TABLE 1 DESIGN EXERCISE – CONCEPT A

TABLE 1 DESIGN EXERCISE – CONCEPT B

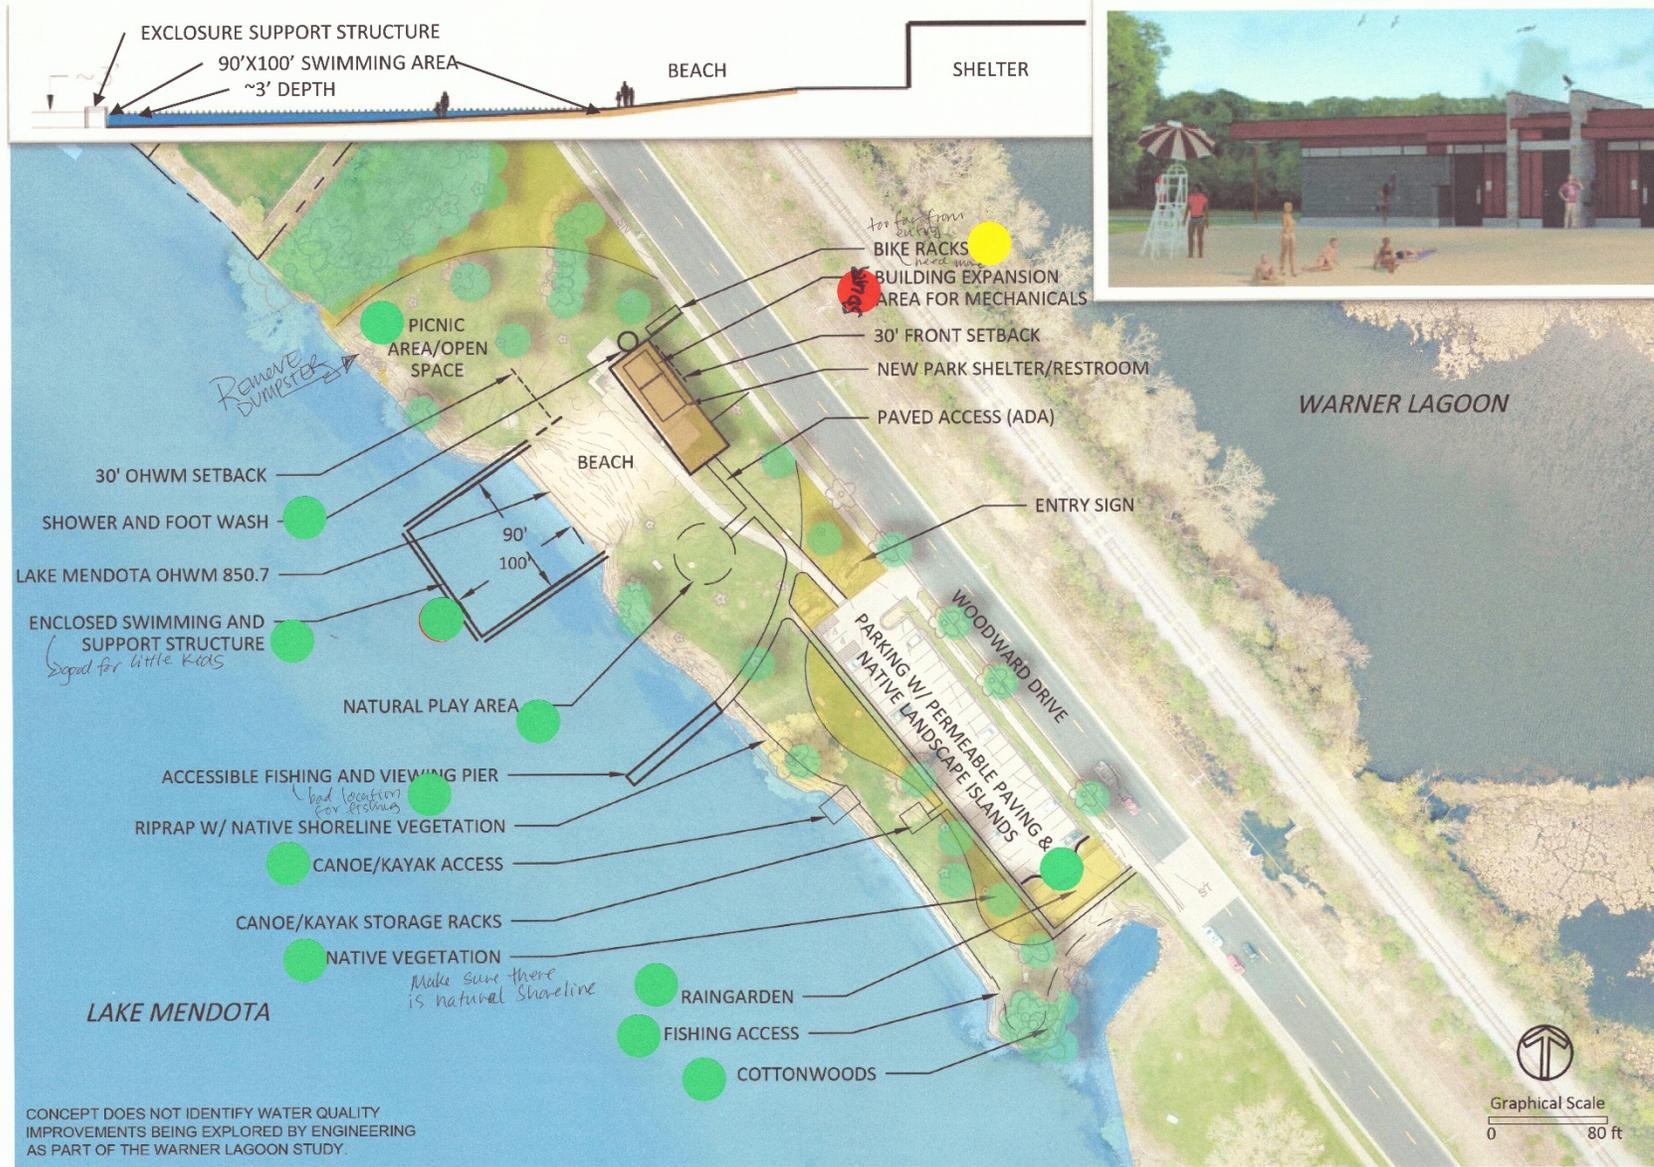
- Liked the angle of the shelter in Concept A, but concerned about getting enough shade.
- Sparked general conversation of folks who like concept A but want it mirrored for better shade.
- More bike racks.
- Liked the native vegetation natural play area, canoe/kayak storage racks, fishing access, shower and foot wash, and new building.

TABLE 2 DESIGN EXERCISE – CONCEPT A

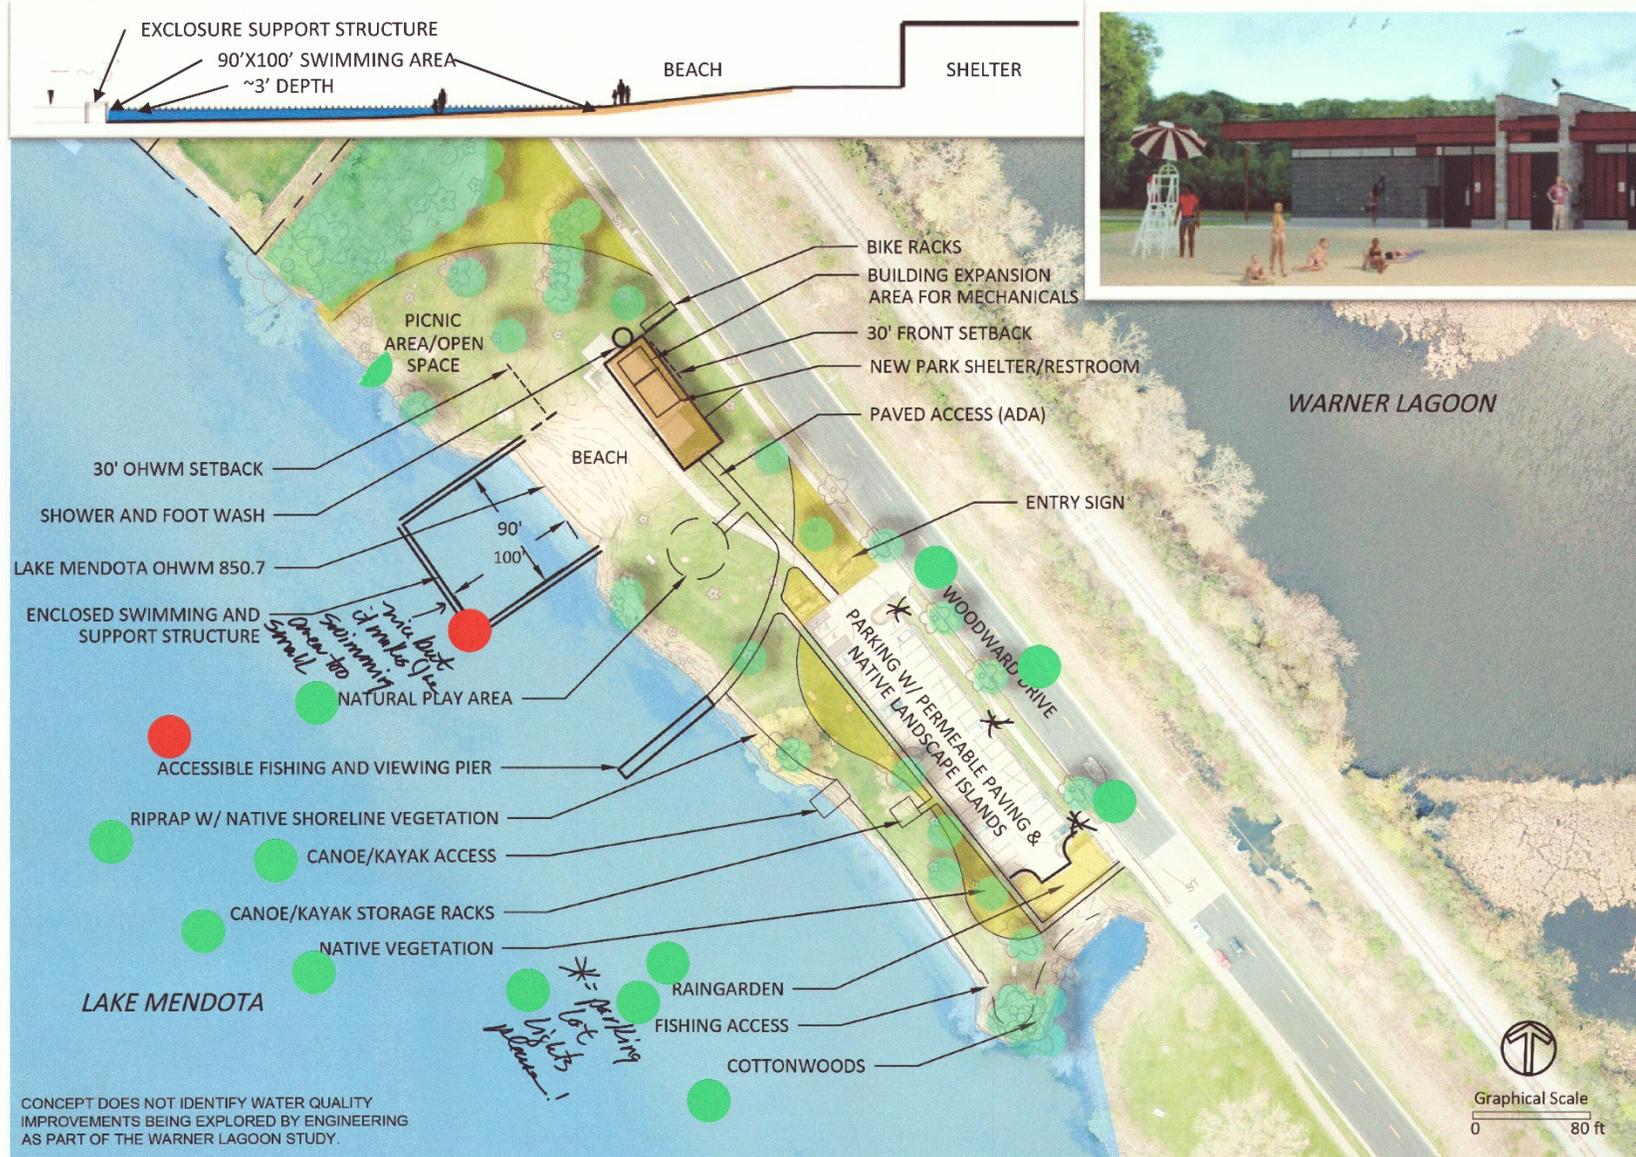
- Want a separate T-shaped swimming pier for fishing and one for boating.
- Like angled shelter but would like to see it mirrored.
- Would like to preserve views along shorelines. If native plants are installed along shoreline they should be shorter.
- Would like to increase lighting in parking lot.
- Liked option A better.
- Foot wash should be on concrete away from sand and away from people sitting at shelter.
- Play area should be closer to shelter.

TABLE 2 DESIGN EXERCISE – CONCEPT B

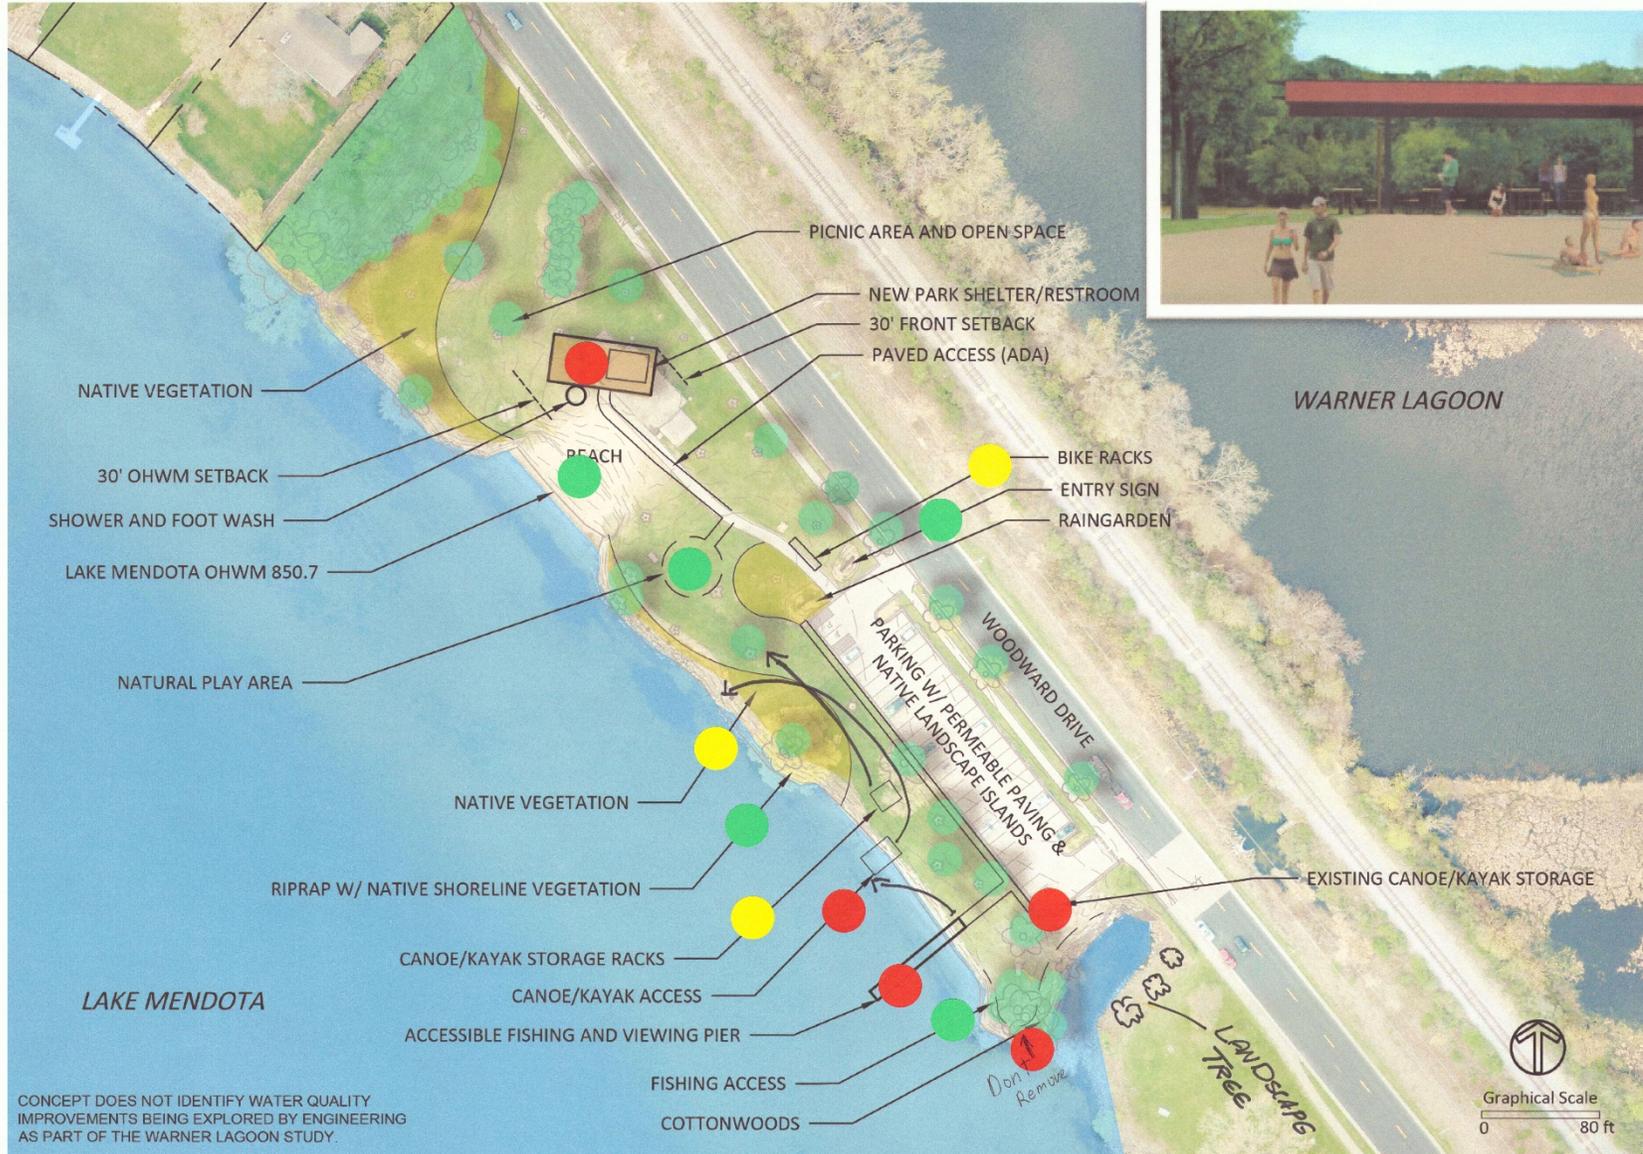
- Might like the enclosure swimming area but feels that it makes the area too small.
- Would like lights in the parking area.
- Want play area where people in shelter can see.
- Like direct access to water with natural lawn and natural shoreline along parking edge so long as kids can walk to the shore from the parking area.
- Also okay with short native vegetation along parts of the shoreline.

CONCEPT DOES NOT IDENTIFY WATER QUALITY IMPROVEMENTS BEING EXPLORED BY ENGINEERING AS PART OF THE WARNER LAGOON STUDY.

TABLE 3 DESIGN EXERCISE – CONCEPT A

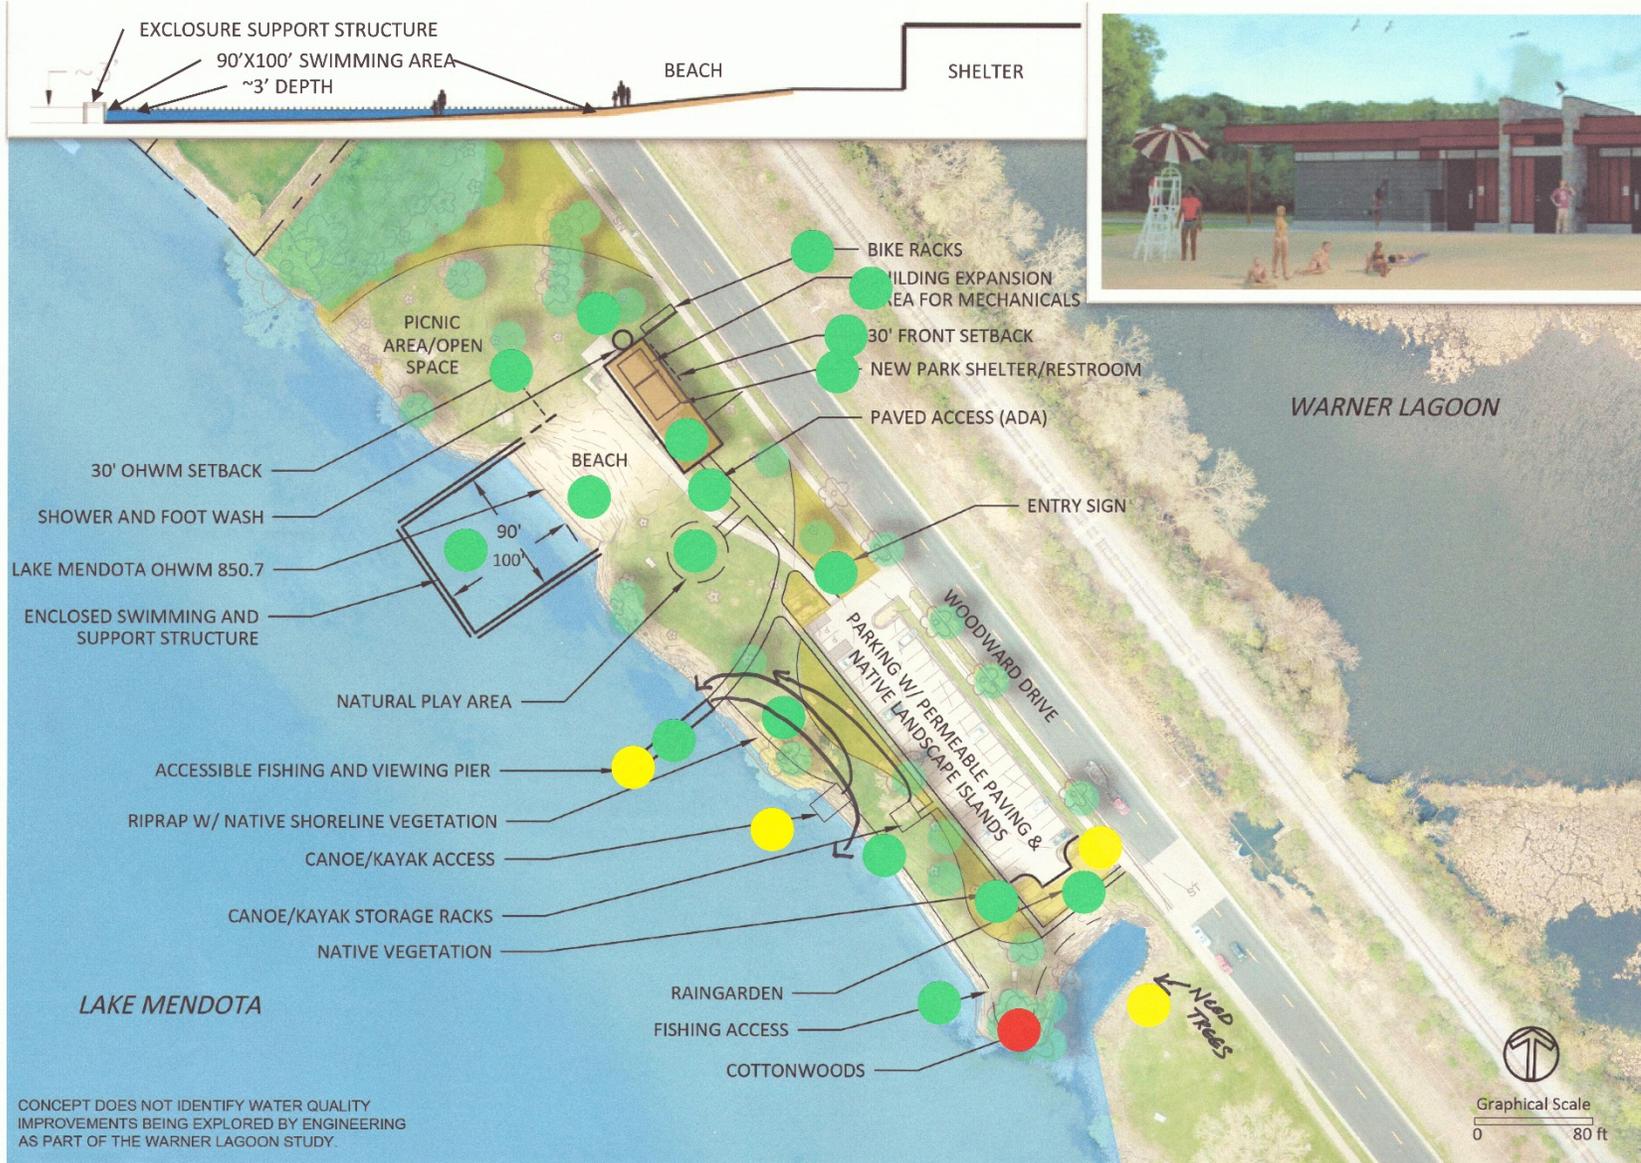
- The location of the fishing pier should be where the canoe/kayak access is located and the canoe/kayak access should be moved closer to the beach area.
- Fishing access is important. The area along the shoreline at the parking lot, to the lagoon is very popular for fishing.
- Would like non cottonwood trees planted on the south side of the lagoon outlet.
- When a tree was removed which allowed sunlight to the lagoon outlet area the fishing conditions changed.
- Bike rack too close to parking lot, move it closer to the shelter.
- Like shower, don't like the position of the shelter because it doesn't shade folks from noon to 7 pm which is when it's most used. Want overhand facing east for shade.
- Bridge over lagoon inlet not needed.
- Liked a little of option A and option B.

TABLE 3 DESIGN EXERCISE – CONCEPT B

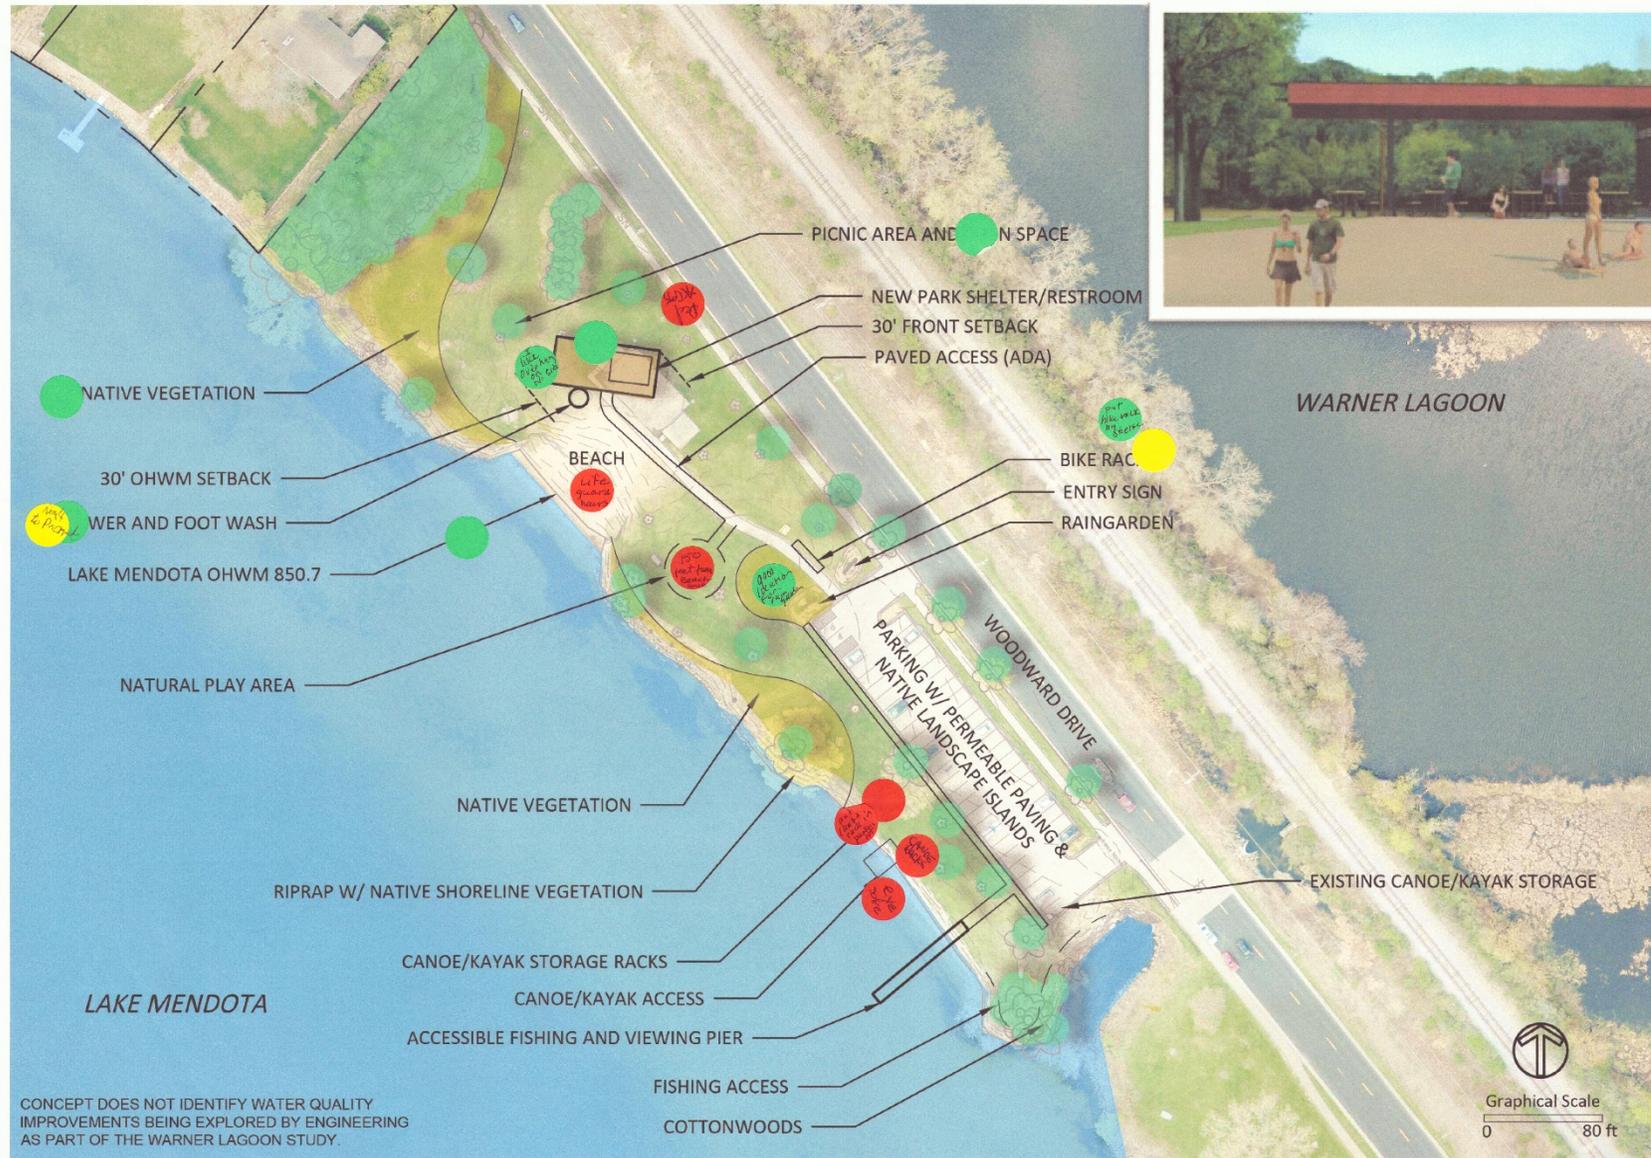
- Switch the locations of the fishing pier and canoe/kayak access.
- The swimmers keep the fish away, so that area isn't good for fishing.
- Need trees along south side of lagoon pipe.
- Liked a little of option A and option B.
